Re: **Culebra Valley Ranch**

MDP # 840-A

The City Staff Development Review Committee has reviewed the **Culebra Valley Ranch** Master Development Plan, **MDP # 840-A**. Please find enclosed a signed copy for your files. Your plan was approved for acceptance, however, please note the following conditions:

REVISED MASTER DEVELOPMENT PLAN

**CULEBRA VALLEY RANCH
MASTER DEVELOPMENT PLAN
PLAN #: 840A
DATE 4/21/05
REVISED 7/24/07**

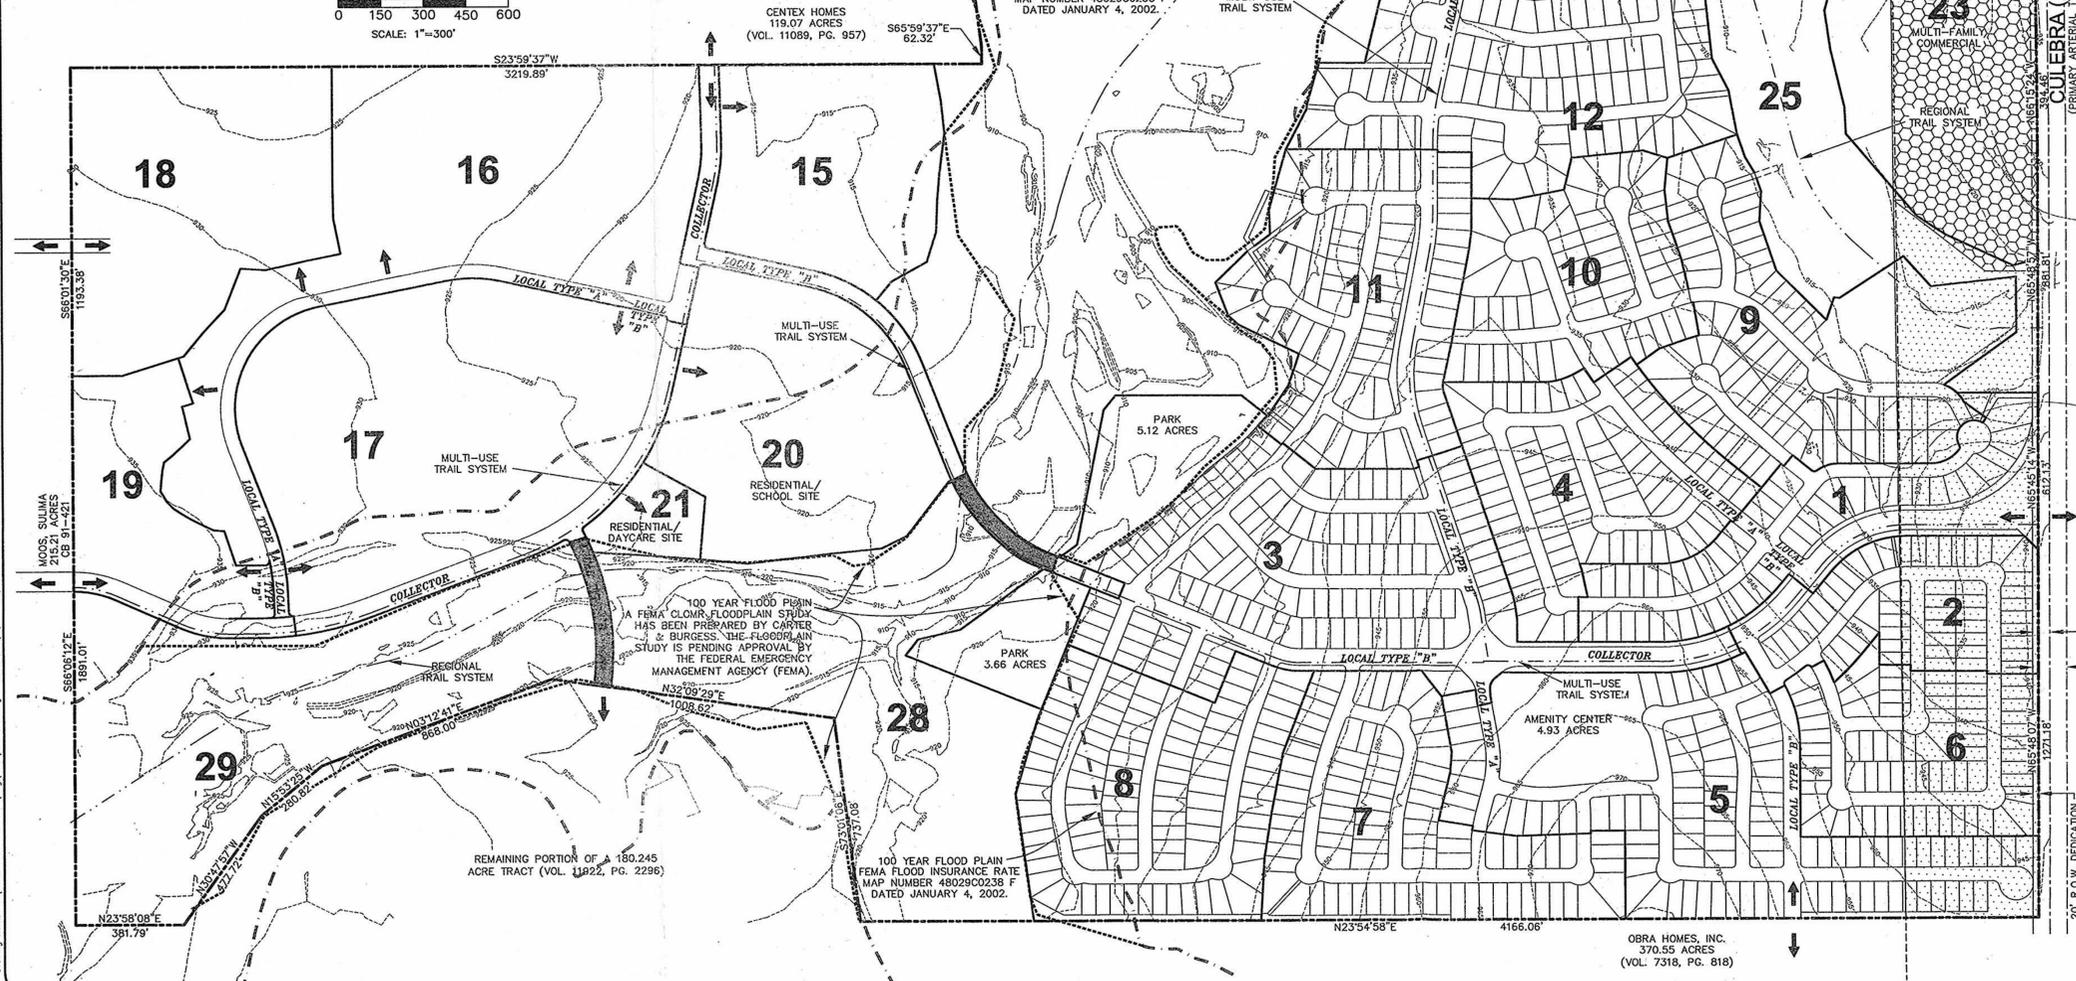
In consideration of public safety and convenience, excessive grades by reason of topography should be avoided in street layouts and arrangements. Any access and R.O.W. issues along state facilities will need to be resolved with the **Texas Department of Transportation (TXDOT)**. For information about these requirements you can contact TXDOT at (210) 615-5814.

- The Traffic Impact Analysis (TIA) and Street Division has reviewed the Level-3 Traffic Impact Analysis (TIA) and the revised MDP for Culebra Valley Ranch MDP # 840-A and has determined that it indicates compliance with TIA Ordinance 91700 and the Unified Development Code.

1. All access roadways shall provide clear sight distance on all existing and proposed roadways in order to provide adequate obstruction free viewing distances for approaching traffic. All signage, landscaping, and improvements shall be selected and located so as not to block clear sight distance areas.

2. All commercial driveways for this project shall comply with UDC §35-506, (r) Access and Driveways.
 3. Driveway throat lengths shall comply with UDC §35-506, Table 506-7 requirements.

4. Coordinate access details for the commercial area at the corner of FM 1560 and along FM 471 with TXDOT.

- The 2006 Tree Preservation ordinance standards per UDC §35-523 require a Tree Preservation Plan prior to any work on site. A Master Tree has been submitted (AP 1372620).
- All right of ways designated as collectors shall comply with Streetscape standards per UDC §35-512. The preservation of existing trees is highly recommended.

- The traffic simulation model indicates that the existing road infrastructure will not accommodate the projected traffic volume. The following improvements should be provided by the developer prior to completion of the last subdivision unit within the Culebra Valley Ranch Master Development Plan.
 1. All intersections from FM 471 and FM 1560 adjacent to this site are recommended to be upgraded per TXDOT standards.
 2. Traffic controls shall be warranted as per the Texas Manual on Unified Control Devices and approved by TXDOT or Bexar County.
 3. Voluntary efforts, beyond those herein required, to mitigate traffic impacts are encouraged as a means of providing enhanced traffic handling capabilities to users of the land development site as well as others, including right turn deceleration lanes along FM 471.

It should be understood that this Master Development Plan is a conceptual plan and controlled access should be maintained in order to uphold safe and efficient traffic flow. Therefore, the developer of this property is encouraged to design common access and shared driveways between all proposed commercial lots. Bexar County reserves the right to address driveways,

- The parkland provided shall be shown as "Park" or "Open Space" on a plat; UDC § 35-503(e) *Designation of Parkland*.
- The parkland provided is dedicated to the Home Owners Association.
- The instruments creating the Home Owners Association are provided by the second application for plat approval; UDC § 35-503(e) *Designation of Parkland*.
- Parkland dedication must be platted by the second phase of residential development; UDC § 35-503(f) *Development Phasing*.
- Parkland in the Floodplain Area shall comply with UDC §35-503(d) (2) *Parkland in Floodplains or Water Features*.
- All amenities must comply with UDC §35-503(h) *Credit for Park Facilities*.
